CLIENT
GREENFIELDS
DEVELOPMENT COMPANY

PROJECT
ORAN PARK
RESIDENTIAL 4
PROJECT
NO 09

LOCATIO
CORNER OF SOUTH
CIRCUIT & DAIRY
STREET, ORAN PARK

SHEET TITLE
LEVEL 1 PLAN

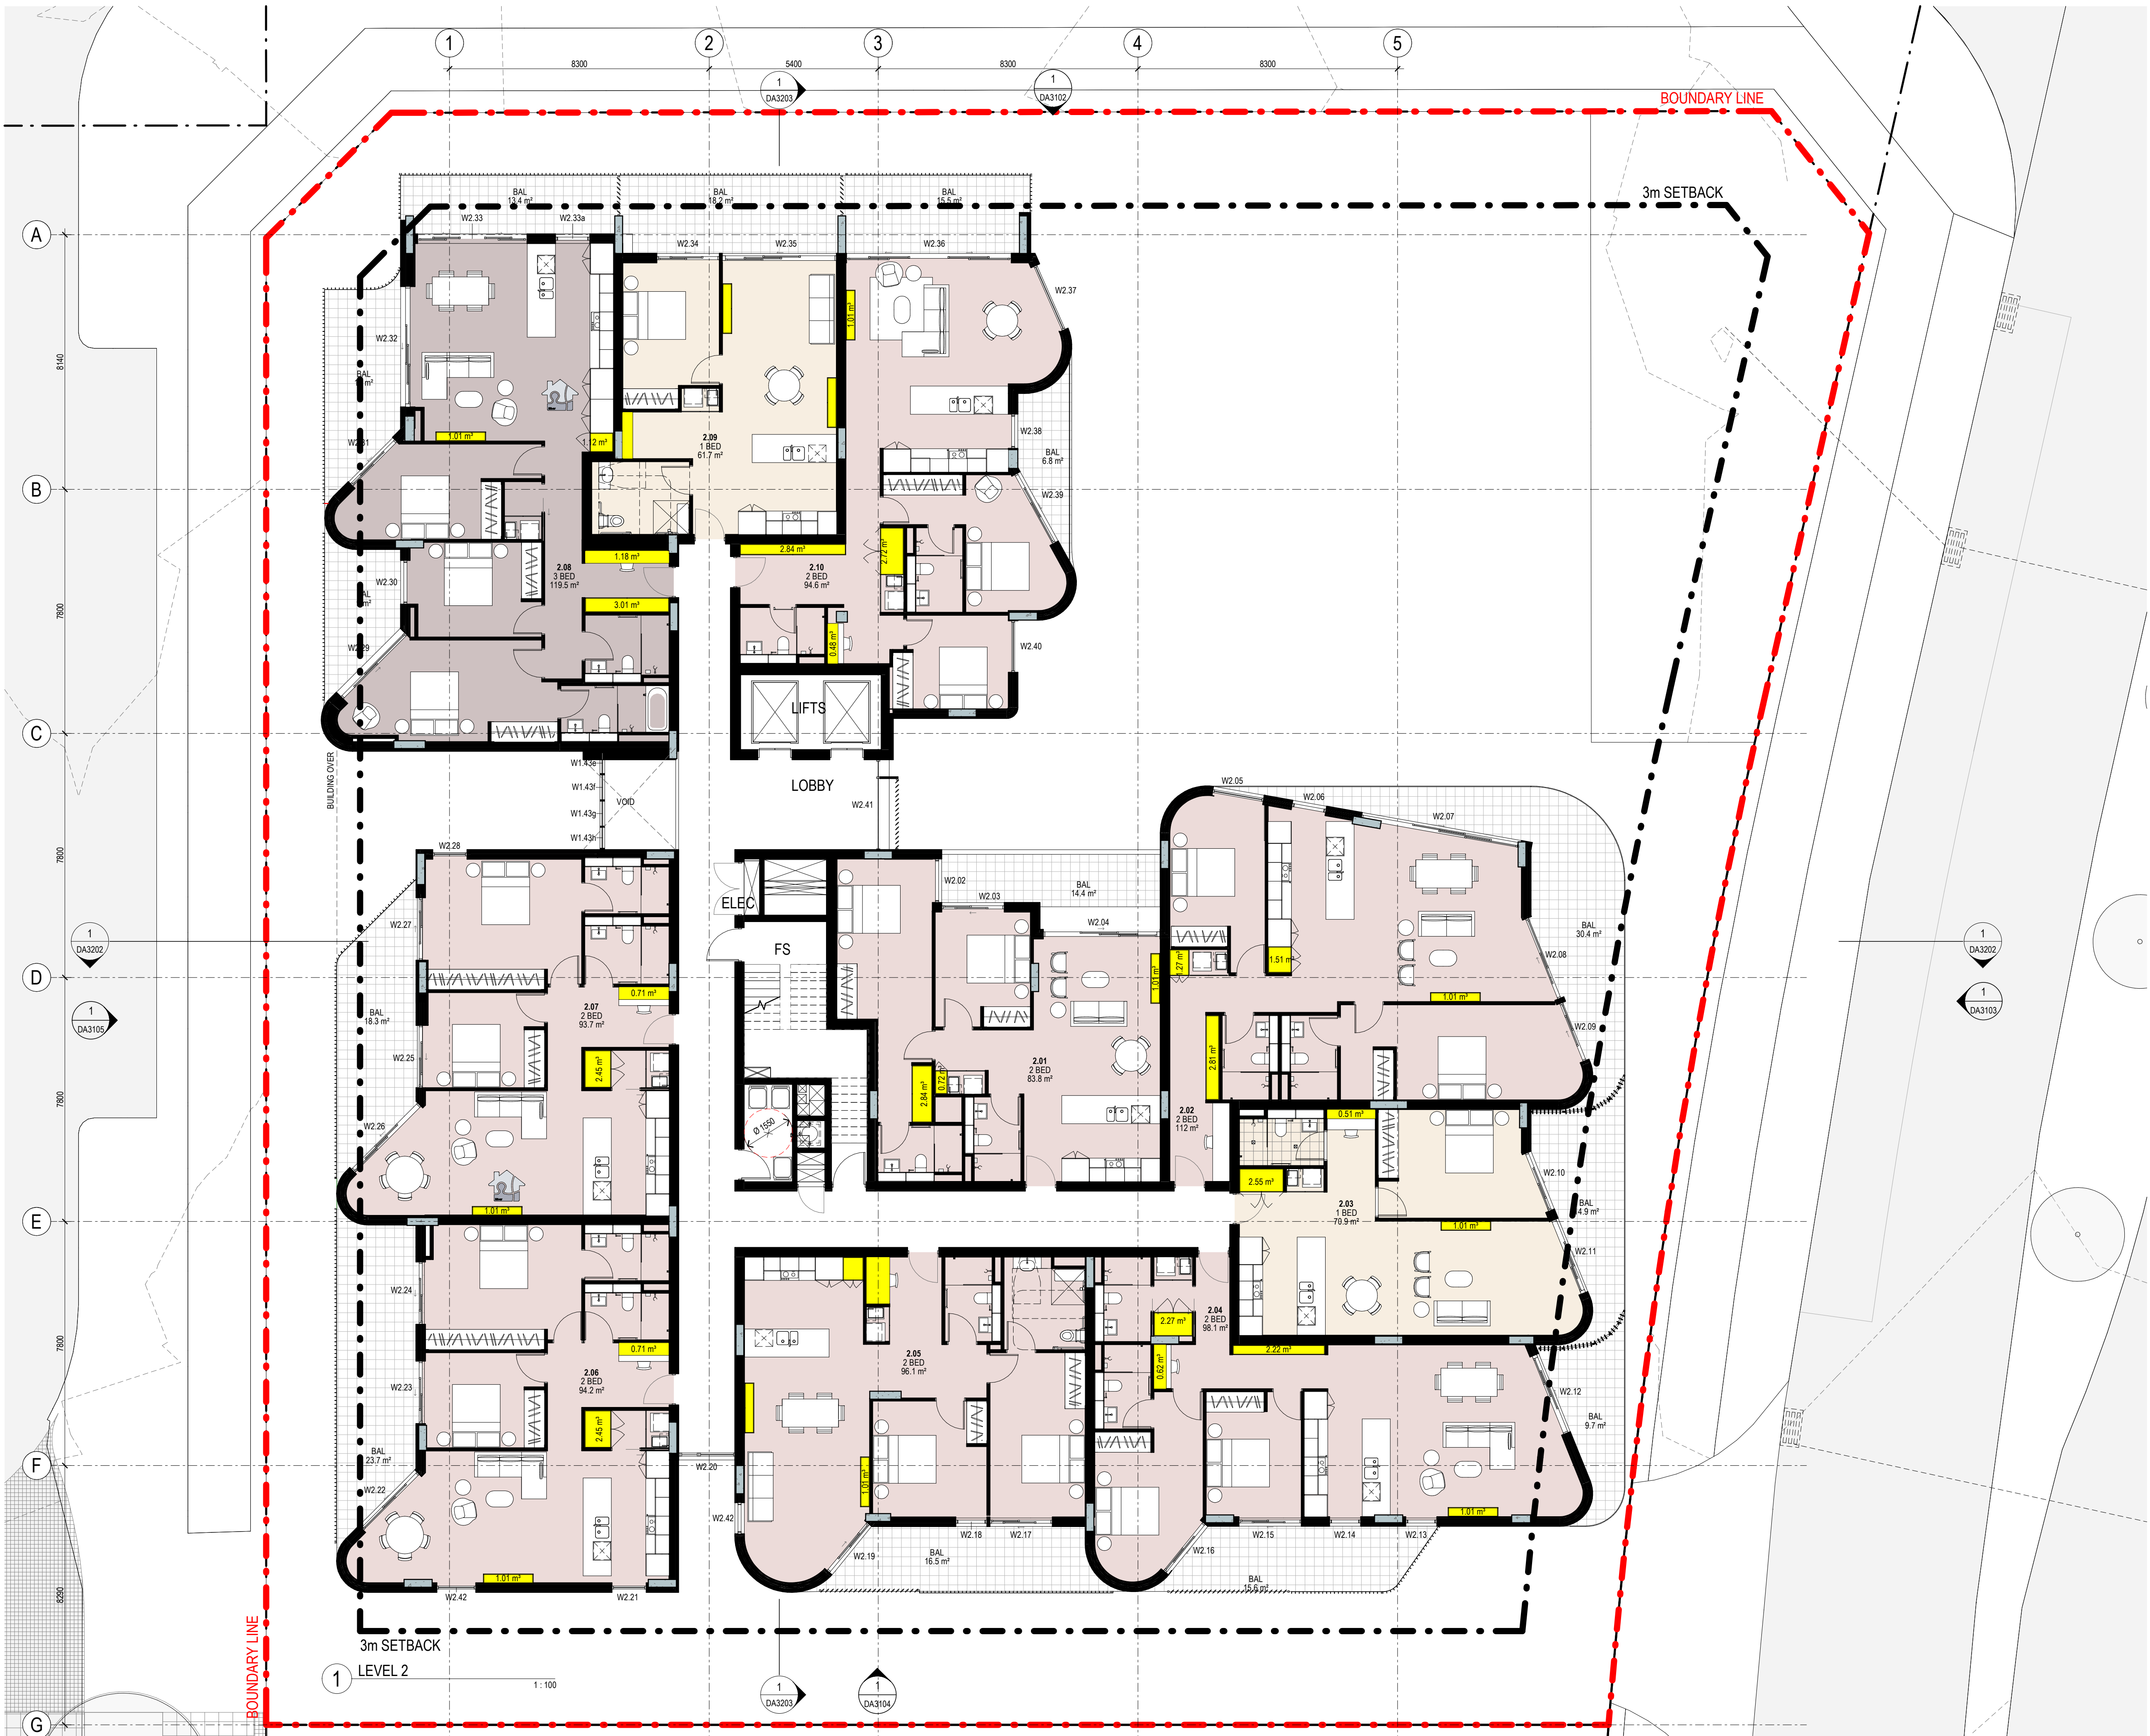
EXISTING TREE EITHER
RELOCATED OR NEW TO
REPLACE - REFER TO
LANDSCAPE ARCHITECTS
PROPOSAL

ADDITIONAL STORAGE ADDED TO
UNITS WITHIN LIVING AREAS

SHEET TITLE
LEVEL 3 PLAN

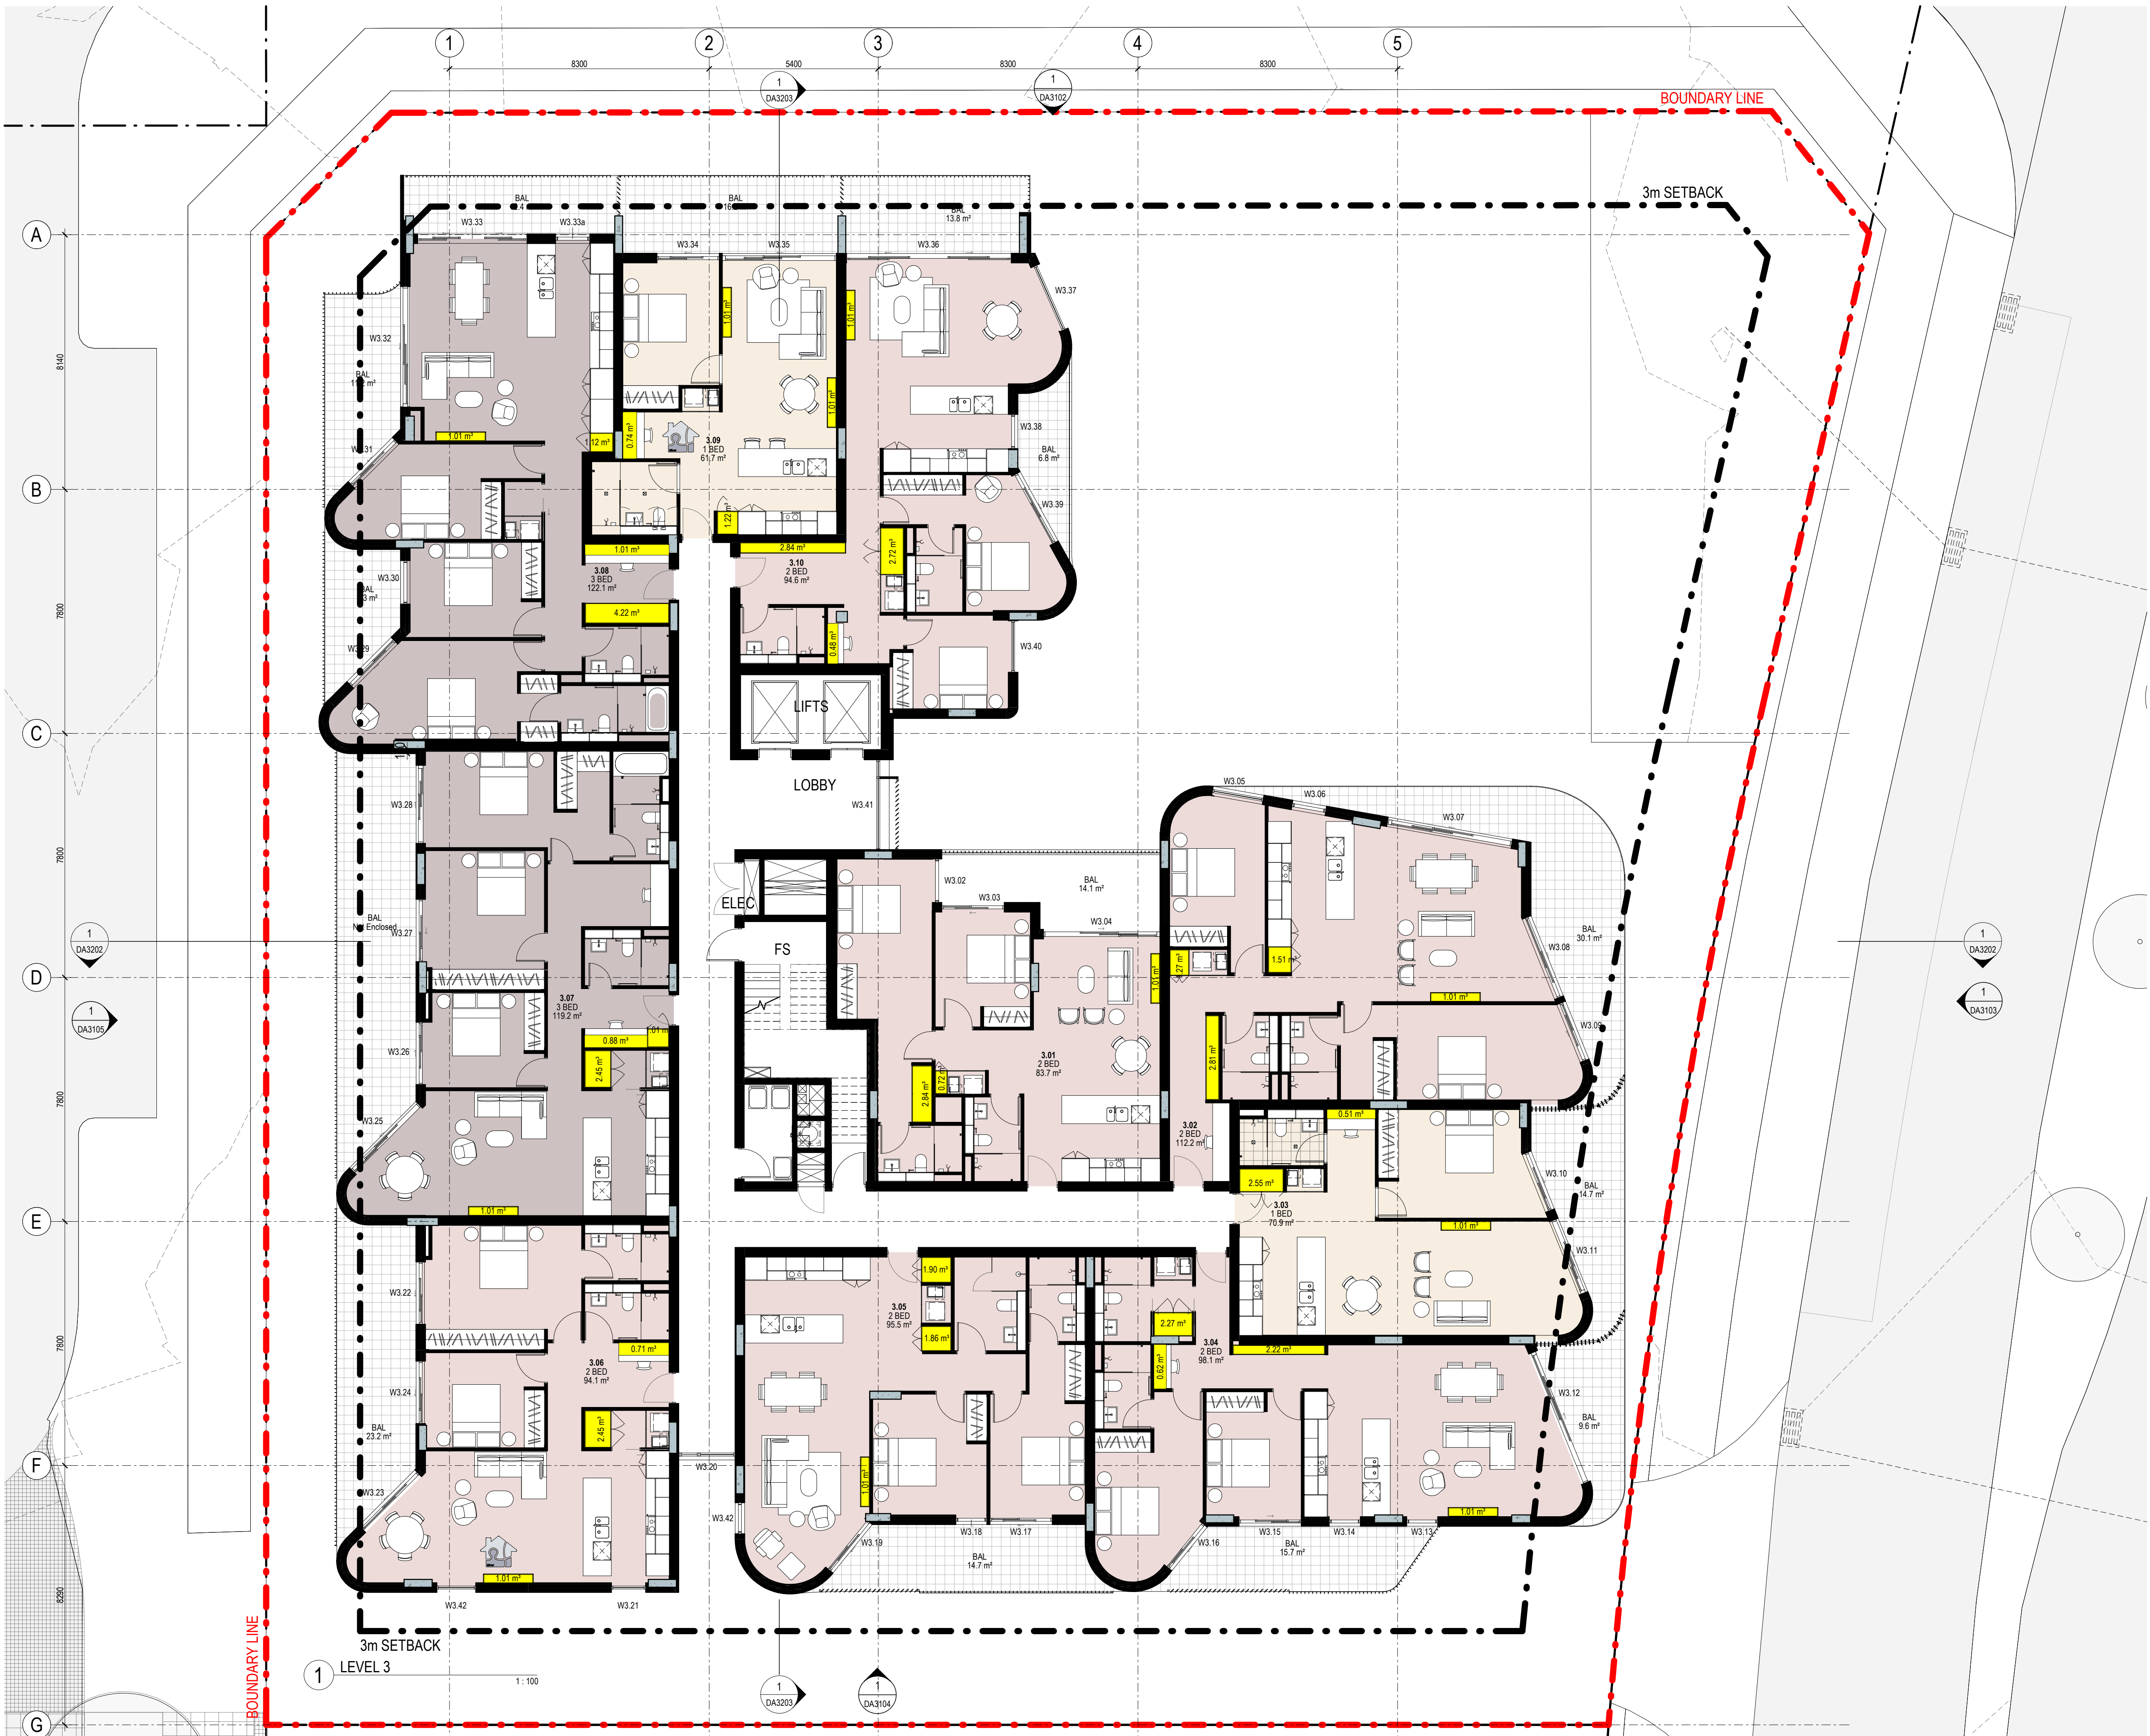
9
EXISTING TREE EITHER
RELOCATED OR NEW TO
REPLACE - REFER TO
LANDSCAPE ARCHITECTS
PROPOSAL

ADDITIONAL STORAGE ADDED TO
UNITS WITHIN LIVING AREAS

SHEET TITLE
LEVEL 6 PLAN

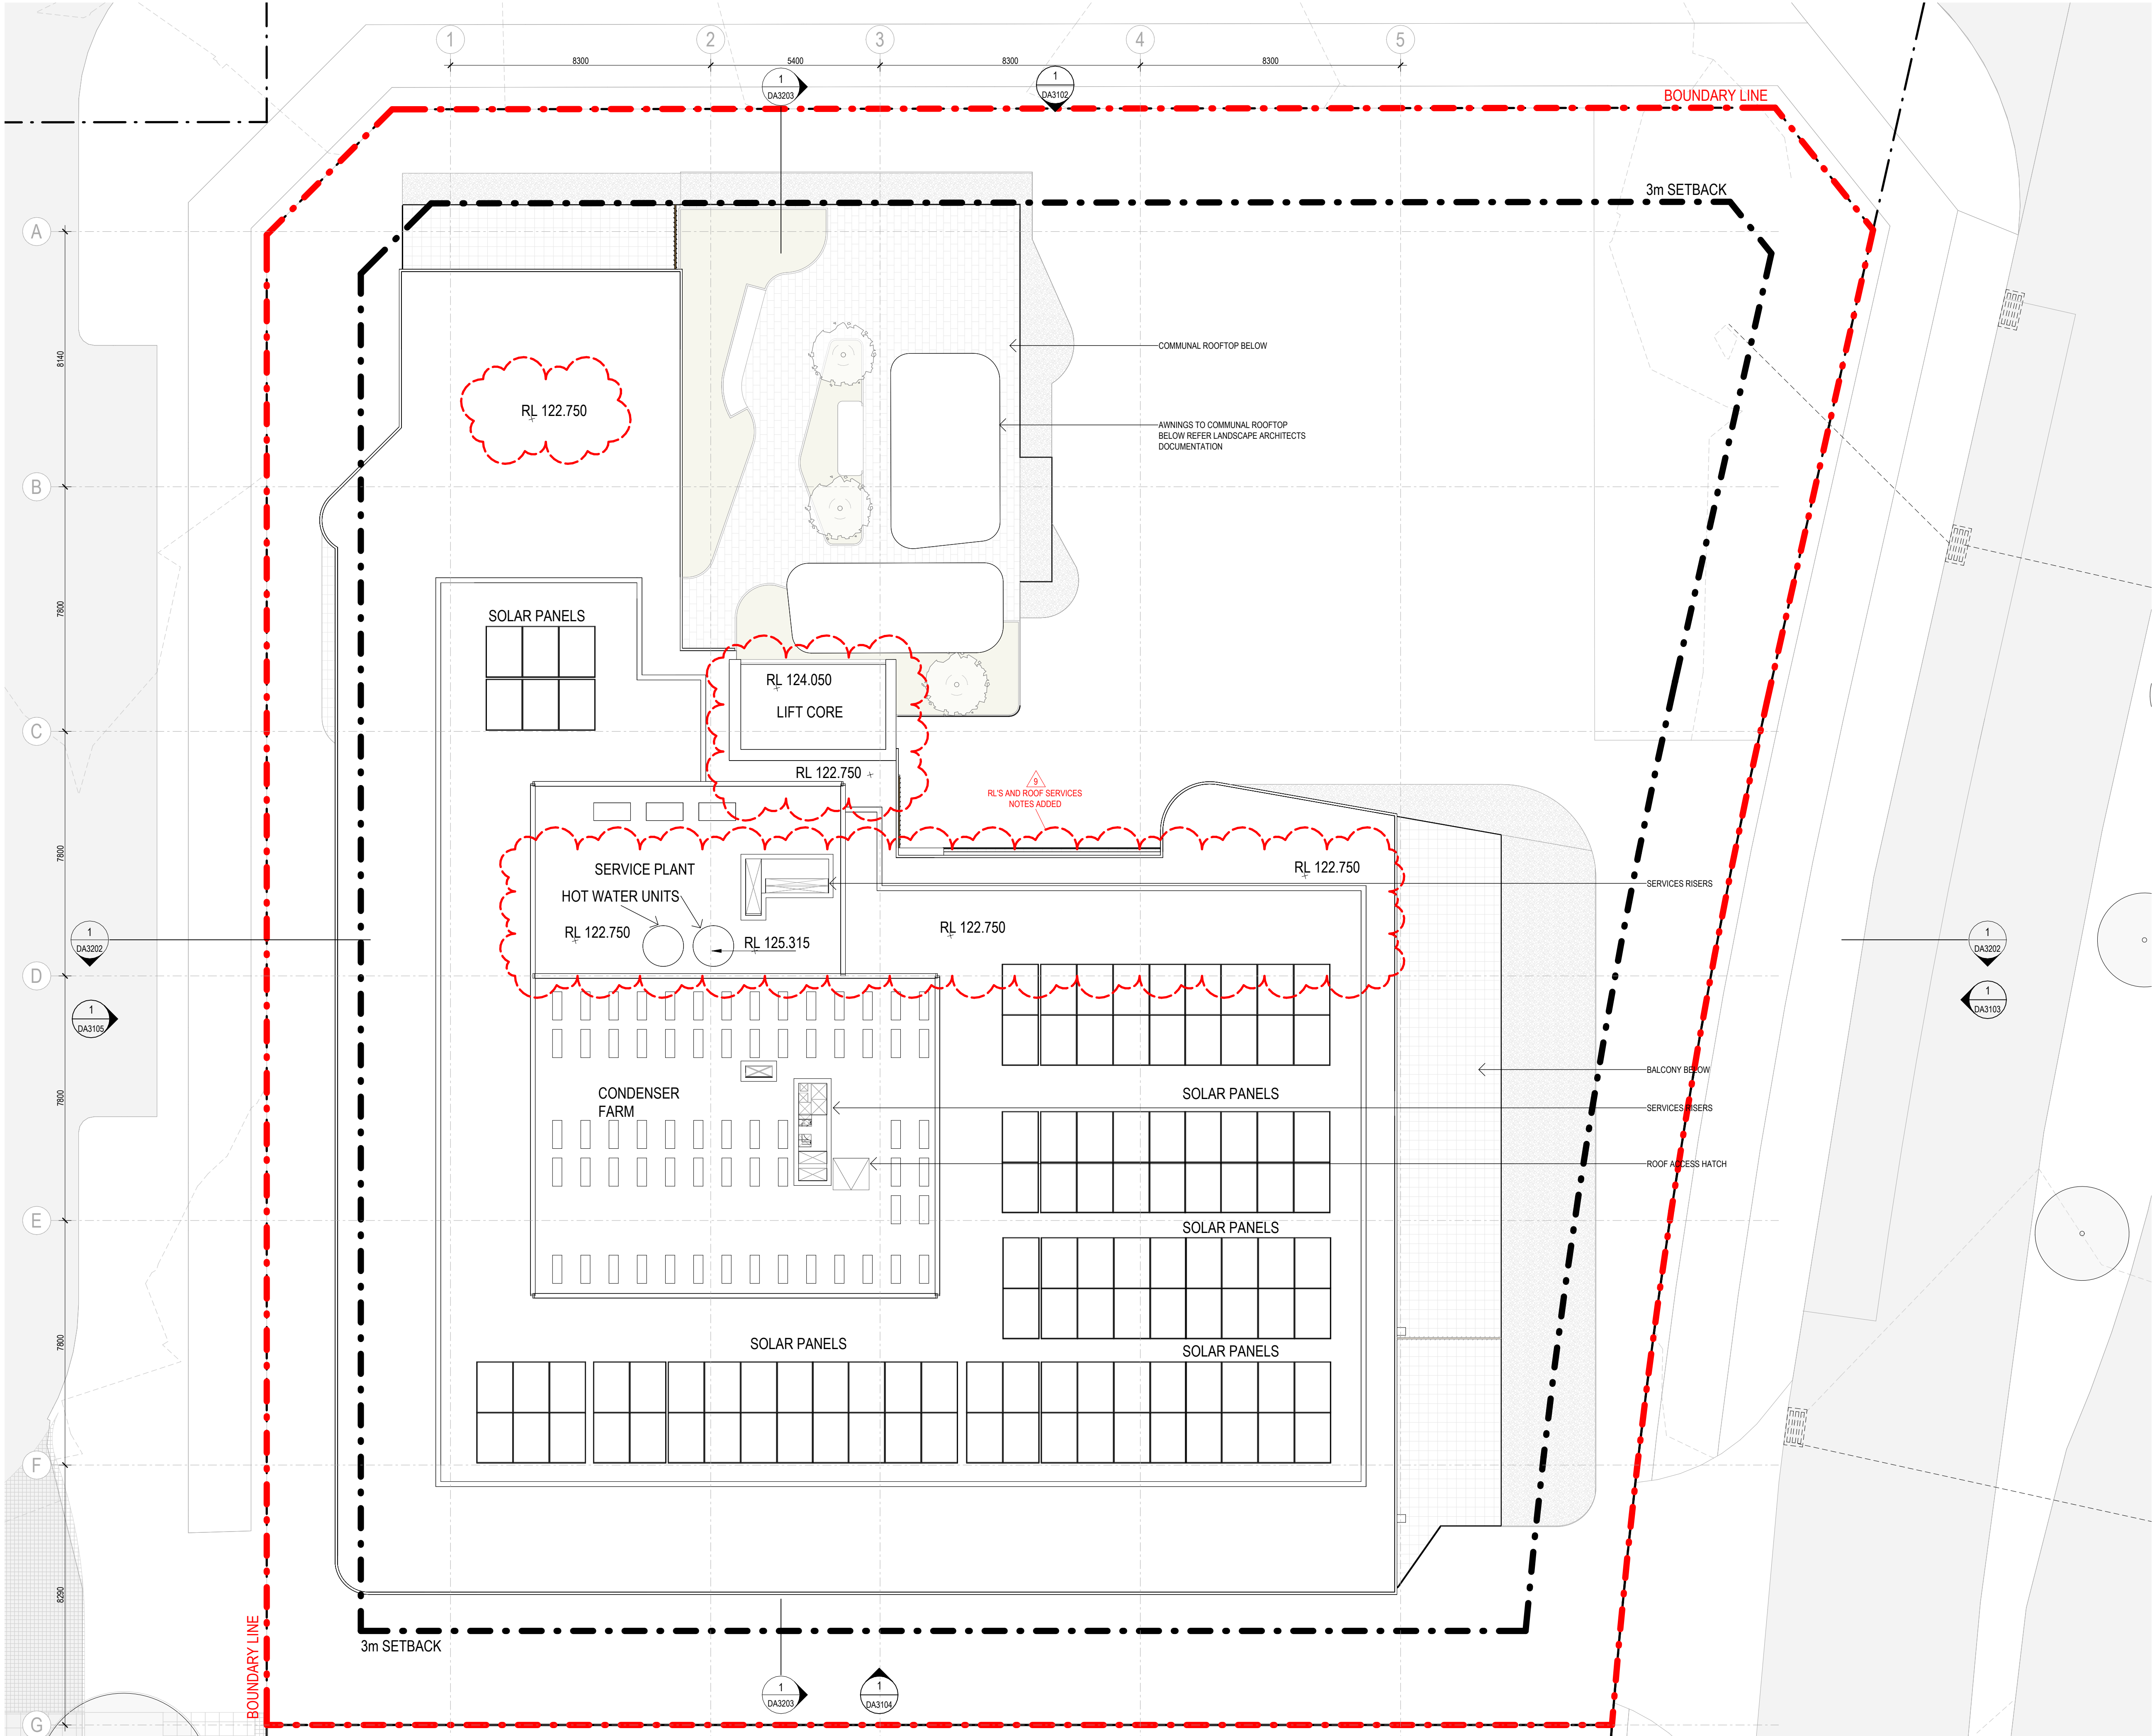
EXISTING TREE EITHER
RELOCATED OR NEW TO
REPLACE - REFER TO
LANDSCAPE ARCHITECTS
PROPOSAL

ADDITIONAL STORAGE ADDED TO
UNITS WITHIN LIVING AREAS
